Re: Pebble Creek Court
Drainage Review
Section 14, Springfield Township

HRC Job No. 20170509.02

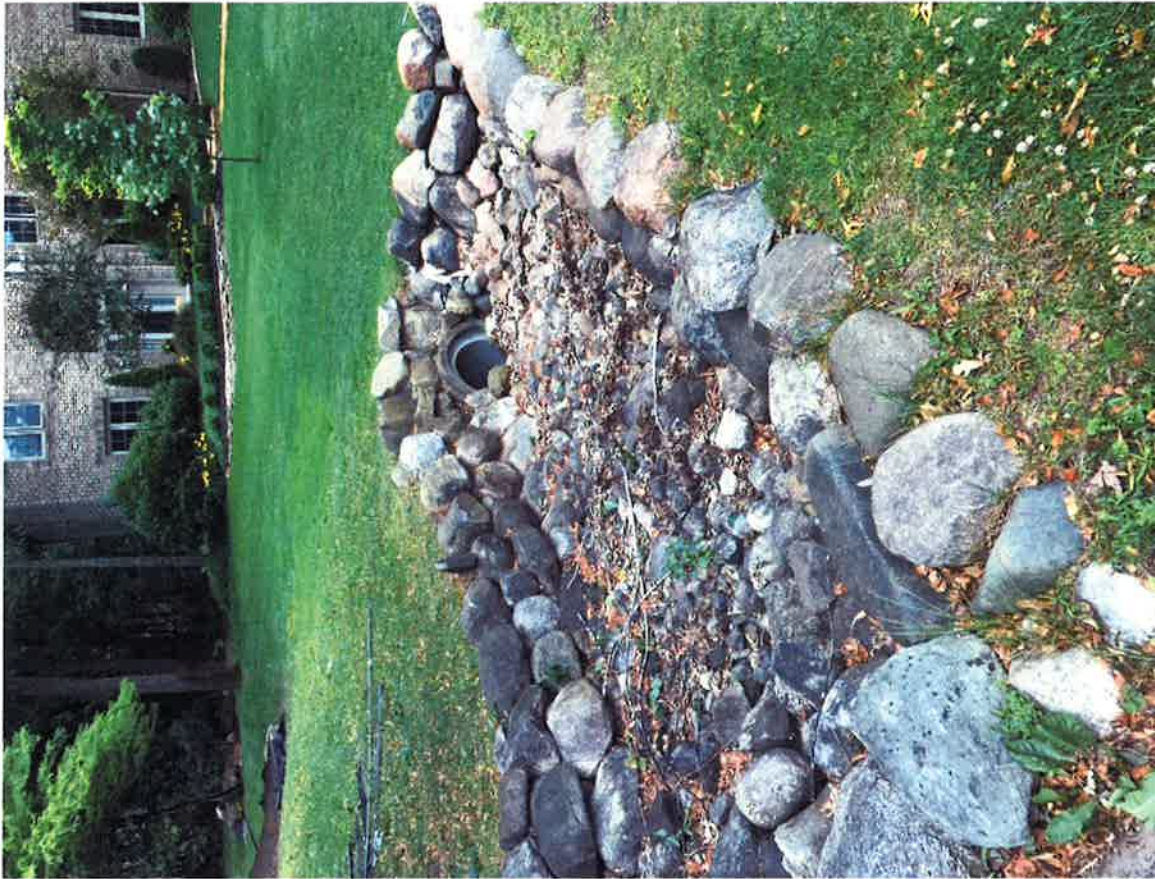
1. There are some apparent construction related issues with the portion of the 12" diameter storm sewer installed along the south right-of-way of Pebble Creek Court. The recent pipe installation runs parallel to the existing ditch line which includes 12" diameter culvert crossings of the driveways for Units 54, 69 and 70. Based on the recent ponding in front of these homes and existing condition of the roadside ditch and downstream culverts, it appears that the immediate issue is the capacity of the roadside ditch and drive culverts to pass the flow to the outlet storm sewer. Exacerbating the problem is the rock lined ditch in front of Unit 70 between the drive culvert and 24" diameter outlet pipe. The attached Photo #1 shows the outlet end of the new 12" diameter pipe extending along the Pebble Creek Court right of way. As evidenced from the photo, there is the lack of a defined roadside ditch adjacent to the new pipe installation. There is minimal if any cover over the new pipe (ref. Photo #2). Photo #3 shows the aforementioned rock lined ditch in front of the 24" diameter outlet. Photo #4 shows the drive culvert for Unit 70. Photo #5 shows the culvert under the drive for Unit 71. Based on visual observations, there are a number of issues associated with the roadside ditch and driveway culverts. The ditch is not well defined. The drive culverts are partially obstructed either by lawn or rocks as noted above. In addition to the new drainage area behind Unit 67, there is offsite drainage from an 18" diameter culvert at the intersection of Pebble Creek Drive and Pebble Creek Court. Photo #6 shows the east end of the 18" diameter culvert crossing of Pebble Creek Drive. The original subdivision plans show acreage to the south including Boulder Court draining via the 18" diameter cross culvert down Pebble Creek Court. Factoring in this upstream tributary area, it does not appear the existing roadside ditch is capable of handling the new storm sewer discharge from the rear of Unit 67. Also, the flow down Pebble Creek Court to the outlet culvert is impeded with the placement of the rocks in the ditch line as noted above. All of these factors help explain the current issues prohibiting proper conveyance of storm water flows down the Pebble Creek Court south ditch line.

- 1) Remove recently installed storm sewer along Pebble Creek Court ditch line.
- 2) Remove all 12" diameter drive culverts.
- 3) Extend manhole MH-1 to center of ditch. Lower structure rim to match ditch bottom and replace solid cover with open grate.
- 4) Deepen MH-1 and install new 18" diameter HDPE pipe from MH-1 down ditch line and across drive to Unit 70. Maximize cover over pipe to extent possible.
- 5) Install inlet structures at all deflections in pipe direction and at upstream side of driveways as necessary to capture ditch drainage.
- 6) Install minor drainage swale in ditch line so as to direct runoff to new inlet structures. New pipe to function primarily as ditch enclosure to accommodate upstream flows.
- 7) Remove majority of rocks in ditch line in front of Unit 70 to minimize any impediment to storm water conveyance.
